North Hertfordshire District Council

Building Conservation comments

File Ref: 24/01623/FP & 24/01624/LBC

Address: 94 Tilehouse Street, Hitchin, Hertfordshire SG5 2DW

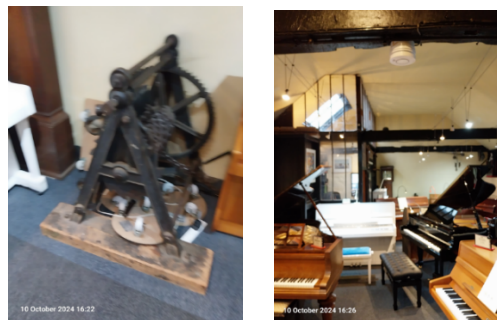
4.2 With respect to point 4. above, it says that '*No change is proposed to the elevation, **other than the insertion of one new rooflight**, so its group value will not be compromised.*' However, it is acknowledged at point 6. that '*a simple, black painted, metal balustrade will be provided for safety as shown on the application drawings.*'
